# **National Electrical Safety Code**

## **Interpretations**

**1961—1977 inclusive**

This edition includes official interpretations of the National Electrical Safety Code as made by the Interpretations Subcommittee of the National Electrical Safety Code Committee, ANSI C2.

Fig IR 104-1

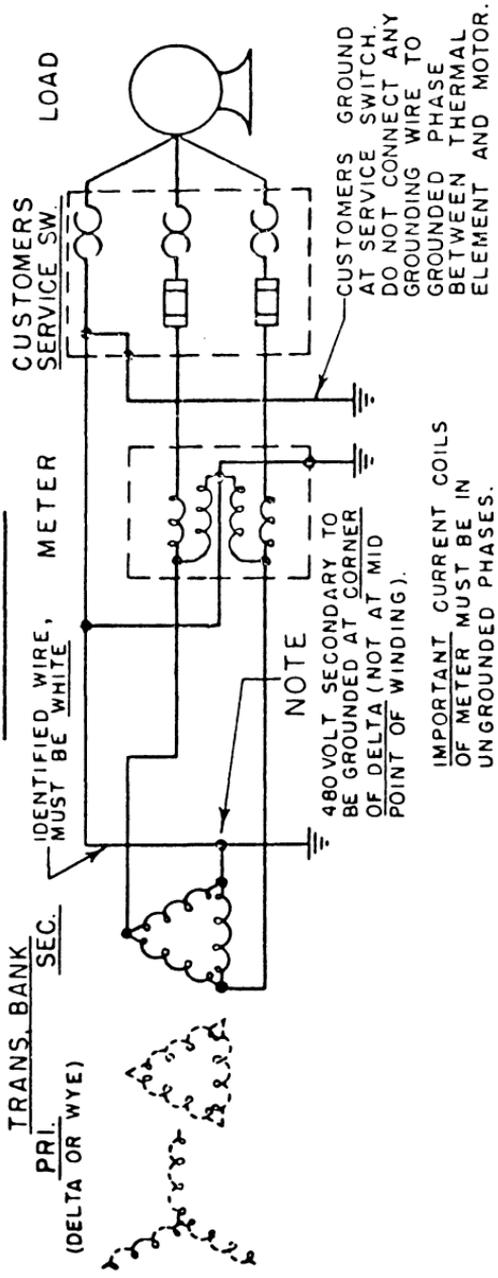
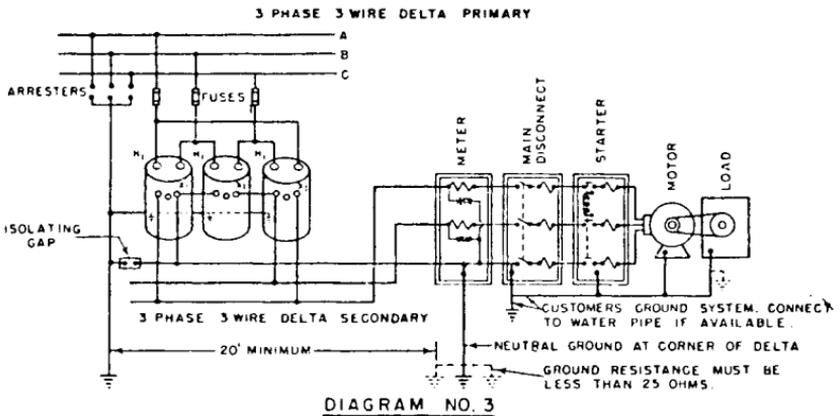
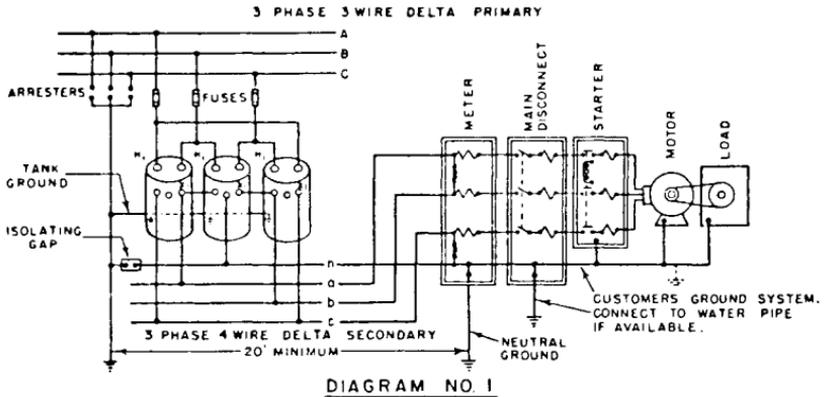
Our specific question is in regard to the sentence in the fourth paragraph of Rule 92B which reads, "In two-wire single-phase and in two- or three-phase systems the ground shall be made at that point of the system which brings about the lowest voltage to ground."

Attached for your reference is a copy of a Metering Drawing (Fig IR 104-1) and a copy of a Grounding Connection Drawing (Fig IR 104-2) for grounding transformers and services on rural lines. On the Metering Drawing the transformer ground connection is made at the corner of the three-phase three-wire delta secondary as shown in the schematic drawing at the top of the page. On the Grounding Drawing the transformer ground connection is made at the corner of the three-phase three-wire delta secondary in Diagram No 3 of this drawing. The meter, main disconnect, starter and motor are also connected to the neutral ground at the corner of the delta.

The attached drawings show the ground connection made at the end of two windings at the corner of the delta which brings about higher voltages to ground. For a 480 V three-phase delta transformer bank with corner grounding the voltages to ground would be 480 and 480.

According to our interpretation the rule 92B seems to prohibit the attachment of the ground conductor at any point other than the mid-point of one of the transformers in a three-phase delta connection.

Fig IR 177

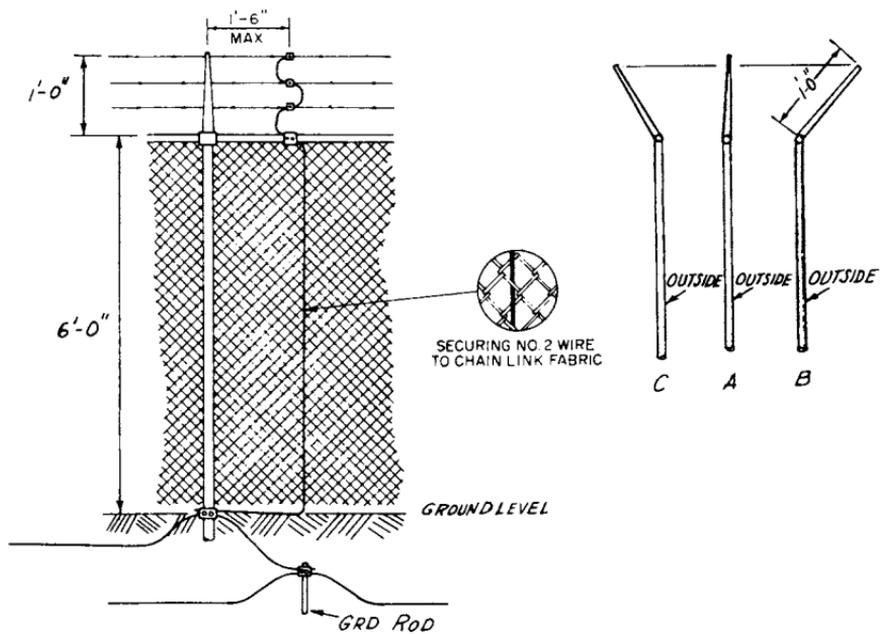
The basic question may be stated: In Rule 110A, is the one-foot barbed wire extension part of the minimum of seven feet in height of the fence, or is it in addition to the seven feet thus making an overall height of eight feet?

Our question is submitted by a sketch (Fig IR 177-1) showing three methods used with the one-foot extension above the existing six-foot chain link fence. The majority of the installation would be using Method A. Can Method B or C be used? Because of the angle of the fence bracket there is a slight reduction in vertical height. Method B gives added protection in preventing easy access to climbing the fence.

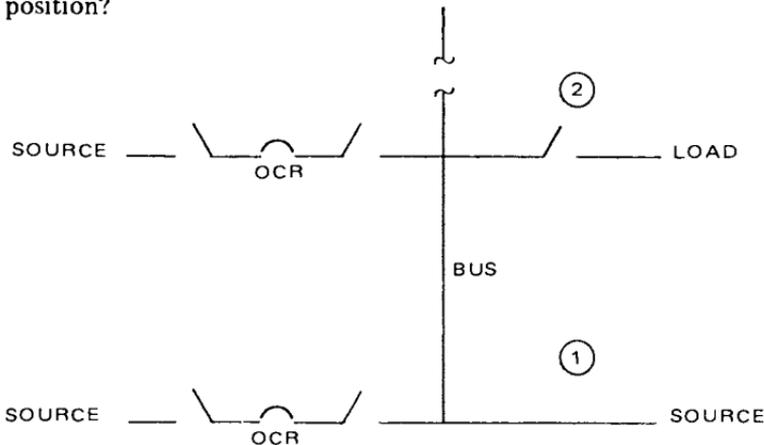
Fig IR-190 shows a partial one-line diagram for a 69 kV switching and substation.

At the location designated 1, the diagram indicates there is not a disconnecting means from the source. Does Part 1, Section 17, paragraph 173C require a disconnecting means?

At the location designated 2, the diagram indicates the switch blade remains energized in the open position. Does paragraph 170, 171, or 173C require the switch blade not be energized in the open position?

With respect to your question regarding energized switch blades, Part I of the code contains no rule which forbids energized switch blades when the switch is in the open position.

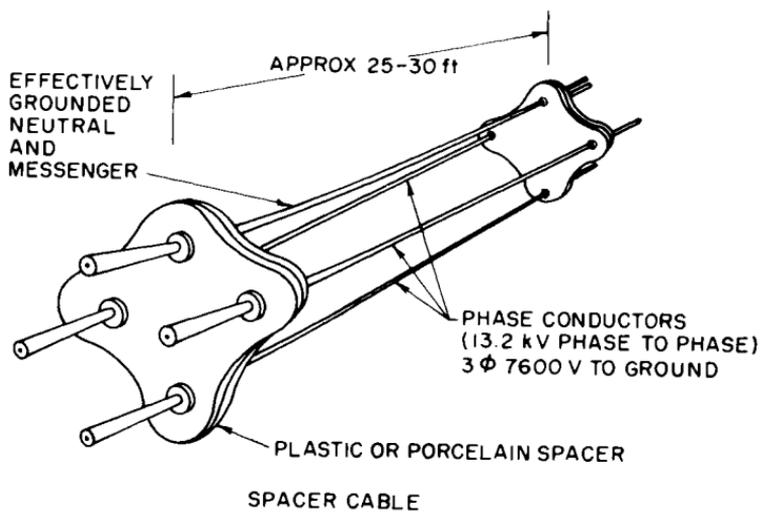
We have been experiencing difficulties with the electric company on the proper interpretation of the expression "supply cables having effectively grounded continuous metal sheath, or insulated conductors supported on and cabled together with an effectively grounded messenger, of all voltages. . ."

In this area the electric companies are using two types of aerial construction in addition to the regular open wire type of construction for primary circuits. The first type is known as self-supporting lashed cable construction and is similar to the type shown in Fig IR-92. The second type is self-supporting aerial spacer type construction employing a grounded messenger which supports the insulated conductors by means of insulated spacers placed at intervals in the span.

We interpret the aerial spacer type construction as being classified the same as open wire because any insulation failure will not cause de-energization of the circuit. However, the electric company wants to classify it as specially installed aerial cable under the Code.

Fig IR 186-1

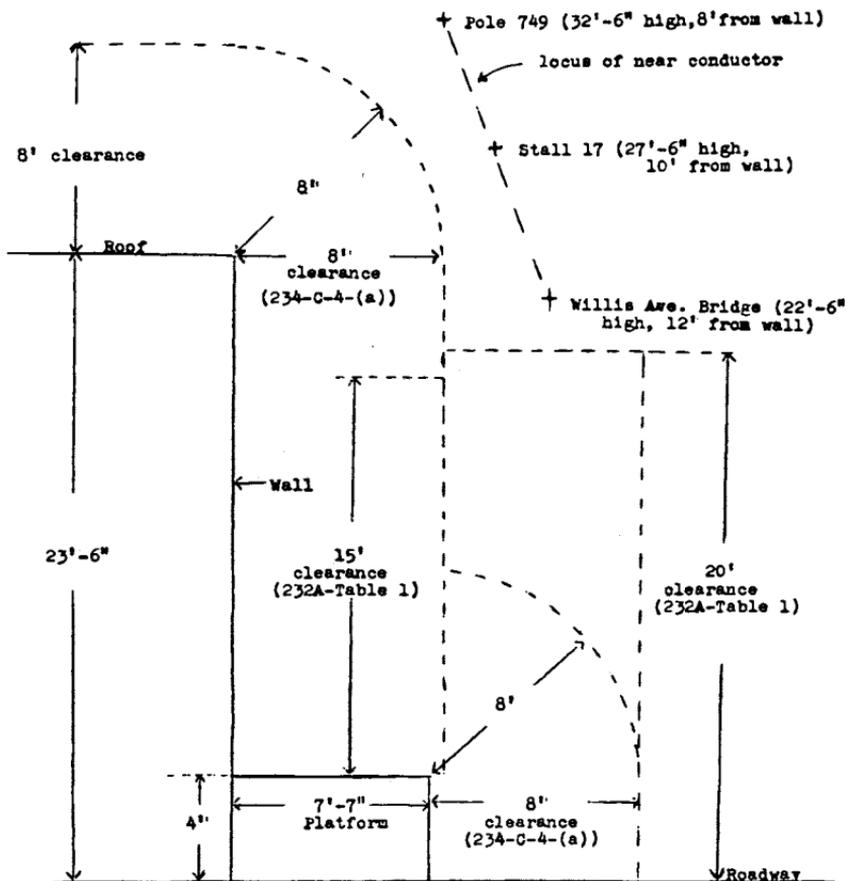
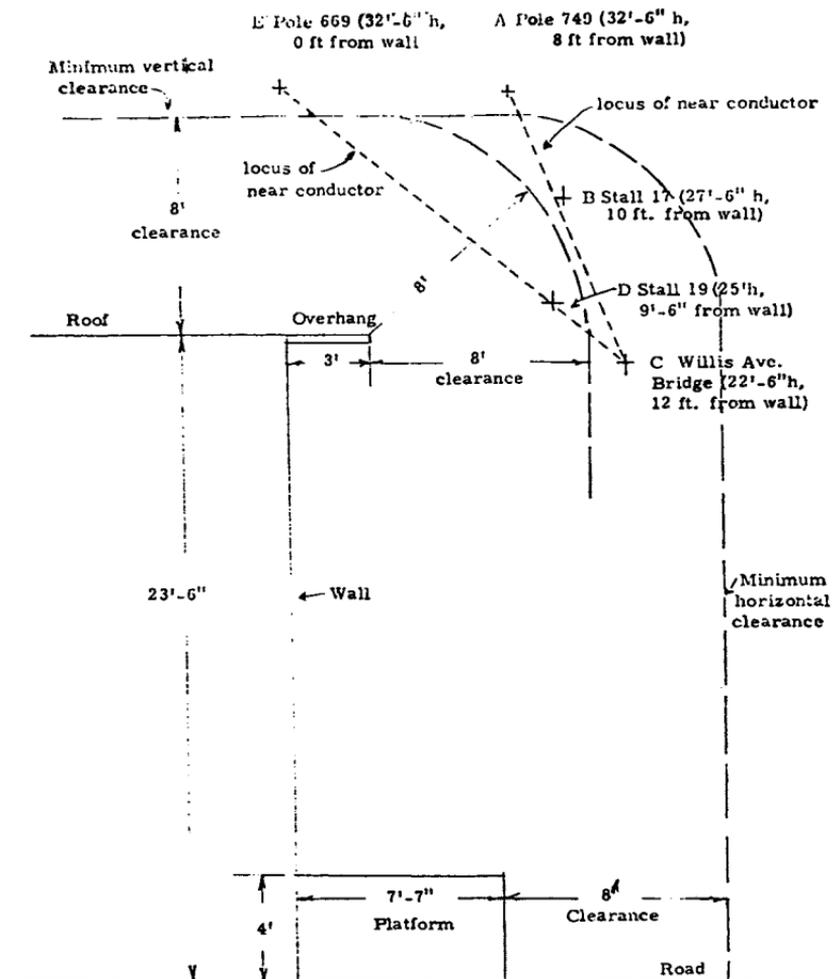
(3) What is the proper interpretation of Sections 232A and 234C(a) as applied to the arrangements of the lower or nearest transmission line at Pole 749, Stall 17, and the Willis Avenue bridge locations? Would you also prepare a diagram indicating how those sections should be interpreted with respect to the facts assumed?

(4) Is the transmission wire an "unguarded or accessible supply conductor" within the meaning of that term as used in Section 234C1(a)?

Fig IR 169

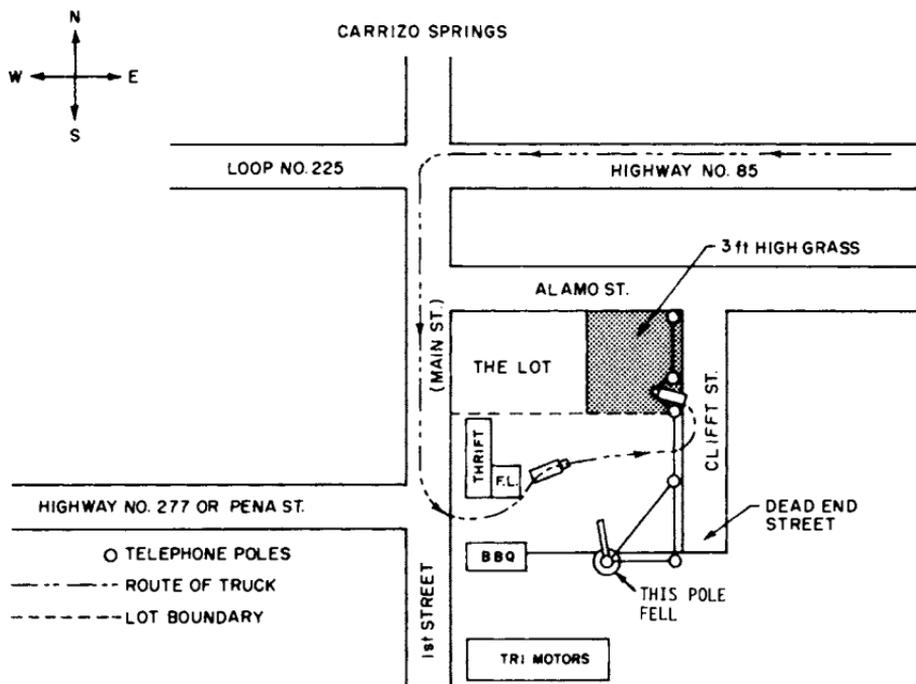
A question arises concerning clearance from the ground for a TV cable which I assume is classified as a community antenna television cable.

dead-end street as can be seen by the enclosed diagram (Fig IR 169). The vacant lot had at least 3-foot-high grass and one particular truck frequently made U-turns under the Central Power and Light wires and got back onto the main street instead of going to the end of the one-block-long dead-end street and making a proper turn onto Alamo Street to get back onto the main street.

On July 21, 1973, the truck, which is 13 feet 6 inches high, hit the TV cable which had recently been installed and caused substantial damage. What I would like to have is your opinion as to what height the community antenna television cable should be from the ground when it borders a vacant lot such as this and the lot is covered by 3-foot-high grass.

Fig IR 187

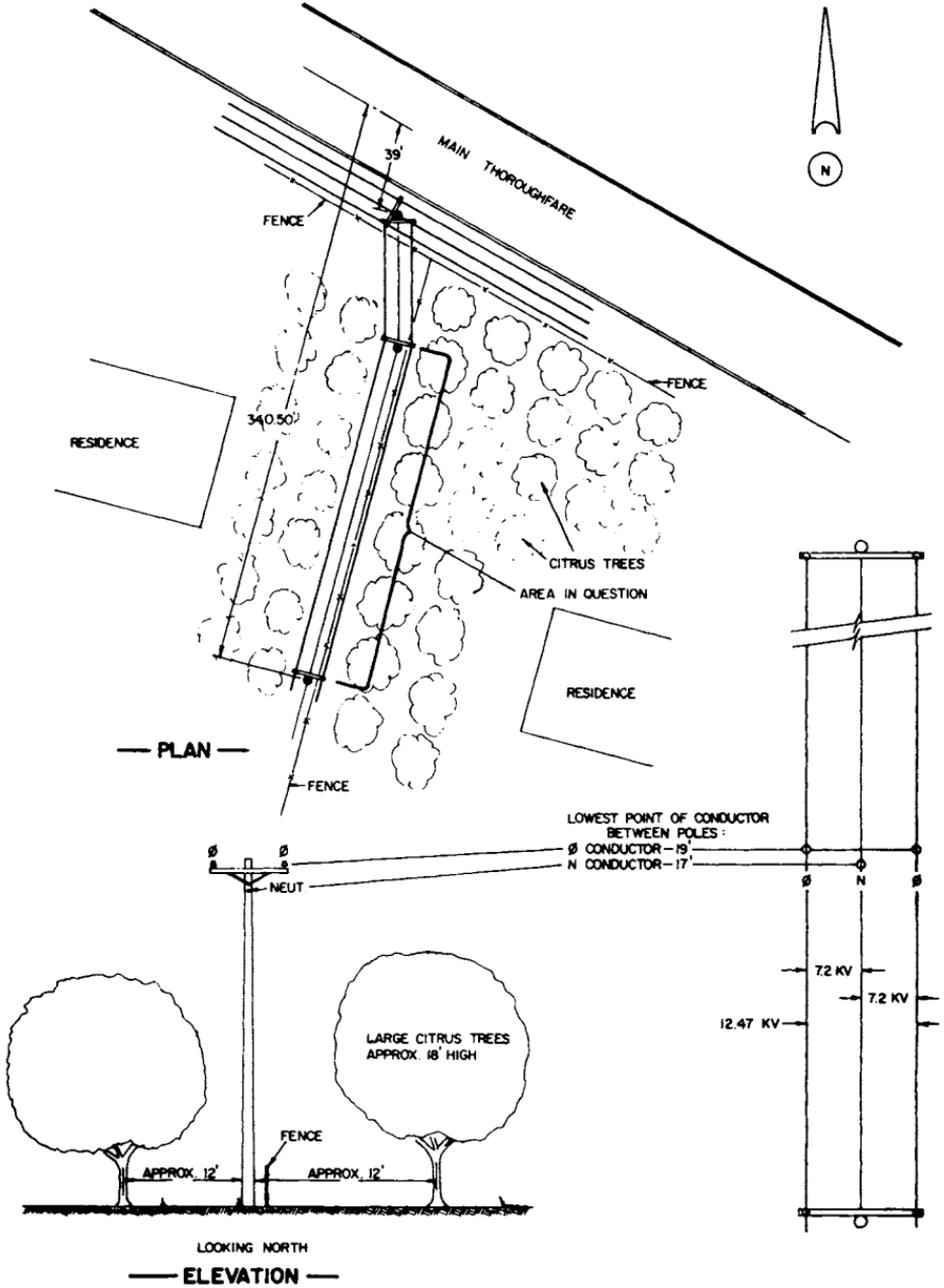
The distribution line is located as shown in Fig IR 187.

In reference to 232A, Basic Clearances, Table 1, does the 15 ft minimum vertical clearance of wires above ground apply to a citrus orchard where there are no established roads or driveways?

Fig IR 158

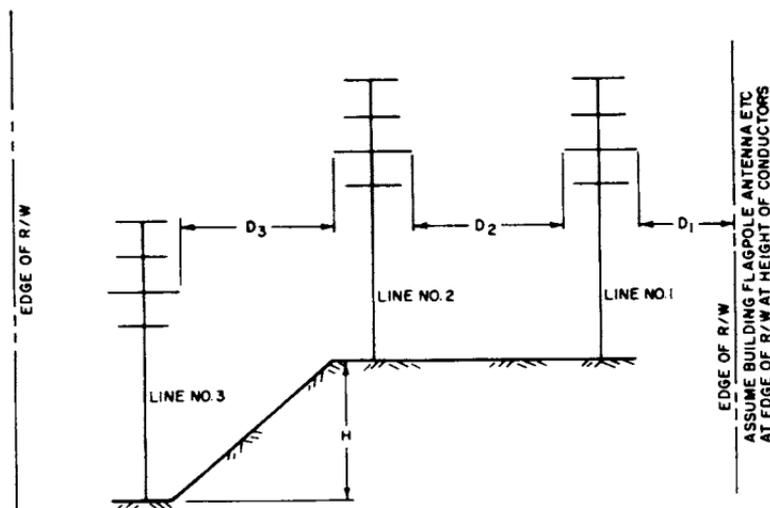
...Fig IR 158 indicates a typical situation with line design assumptions and it is requested that comments regarding the controlling provision(s) or actual distances  $D_1$ ,  $D_2$ , and  $D_3$  (in relation to terms given) be solicited from NESC to clarify "in-house" interpretations.

To determine  $D_1$ ,  $D_2$ , and  $D_3$  as required by the NESC.

NOTE: SECTION "V" SHOWN ON (FIGURE 96-2)  
Fig IR 96-1

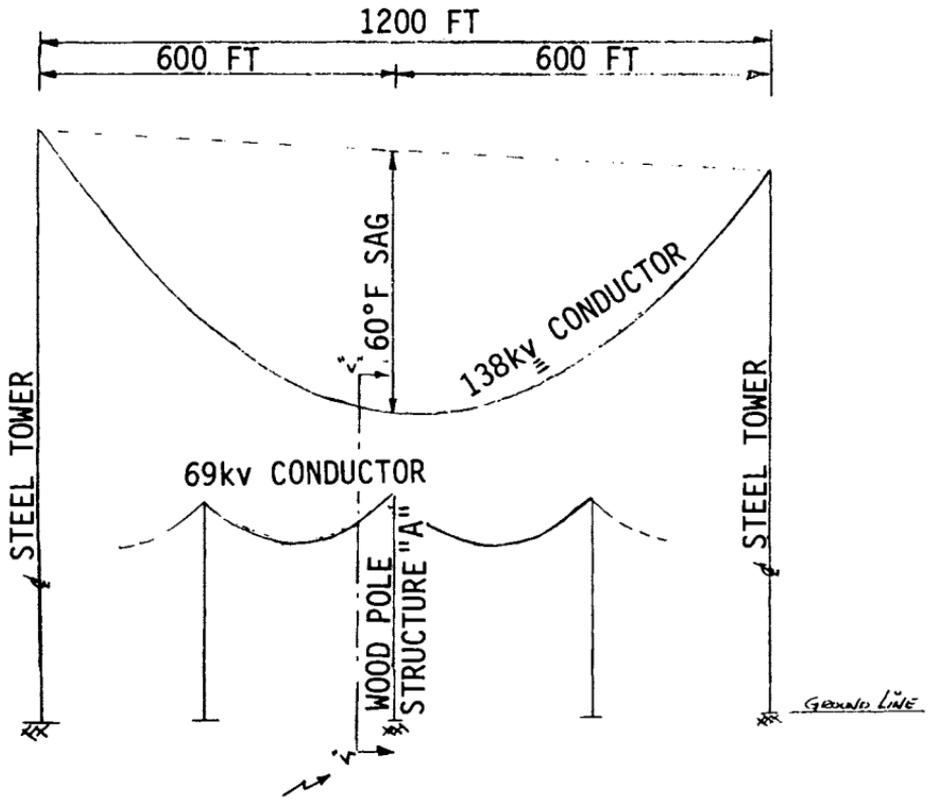
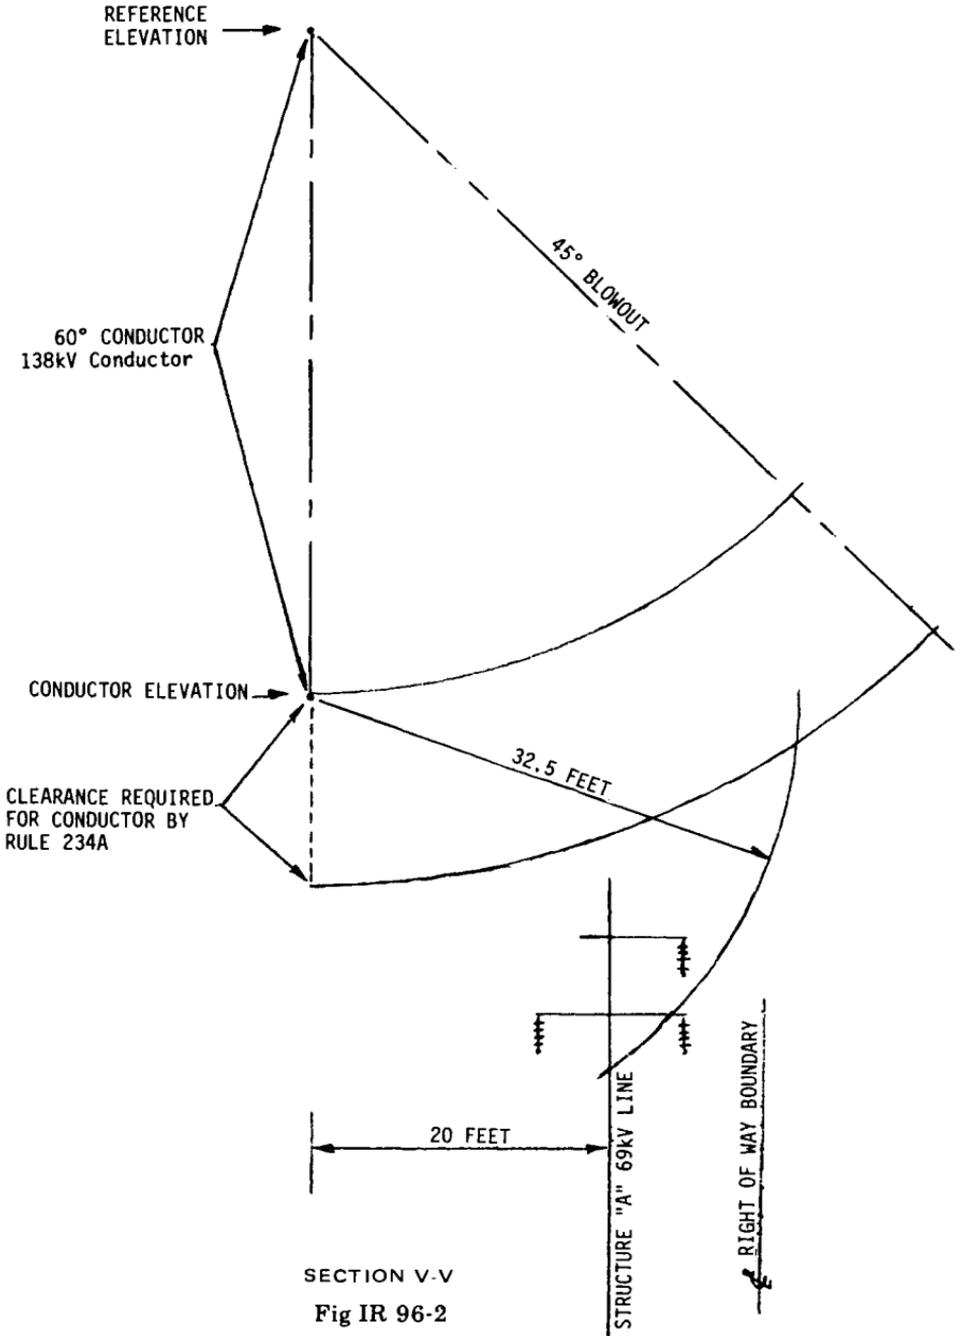
The situation involves the potential installation of a single wood pole, single circuit, 69 kV transmission line on the same right-of-way and parallel to a 138 kV steel tower transmission line. Referring to the attached Fig IR 96-1, the problem centers on the locating of structure "A" of the 69 kV line at the midspan of the 138 kV line offset horizontally 20 feet as shown in Fig IR 96-1.

Referring to Rule 234B, 2, the applicable clearance requirement in this case is dictated by the formula given in Rule 235A, 2, (a), (2); namely, that the clearance equals 0.3 inch per kilovolt +  $8\sqrt{S/12}$  where "S" equals the apparent sag of the larger conductor. This formula gives a required basic clearance of 90 inches. Rule 234B2, specifies that this clearance shall be increased by 1 inch for each two feet of separation between the 69 kV structure and the nearest 138 kV structure. As the nearest 138 kV structure is 600 feet, the 90 inch basic clearance is increased by 600/2 or 300 inches giving a total clearance requirement of 390 inches or 32.5 feet.

As shown on Fig IR 96-2 the location of the 69 kV structure meets the blowout clearance requirements at 45° as specified in the "Exception" clause of Rule 234A. This exception clause, which undoubtedly was added to the Fifth Edition of the code to take care of long span transmission line situations, eliminates excessive conductor clearance requirements. As no such clause exists for Rule 234B we cannot arbitrarily infer and apply such an exception. The clearance requirement appears excessive, however, especially in this case where climbing space does not enter the picture. Climbing space seems to be the prime criteria for the inclusion of the clearance requirement dealing with the distance between the supporting structures of two lines.

Since supply conductors only are involved and climbing space is sufficient, it seems that if the clearance of the 138 kV conductor to the 69 kV conductor or structure met requirements for a line crossing, sufficient clearance would be provided.

Your detailed and clear explanation of the problem is appreciated and the Committee feels that your understanding of Rule 234B, Section 23, as written is correct.

Because your interpretation of Rule 234B is correct, this is an instance where application of Rule 201A might be justifiable. We therefore suggest that you may wish to refer the matter for final decision to the proper administrative authority, probably the Public Service Commission of the State (or States) involved.
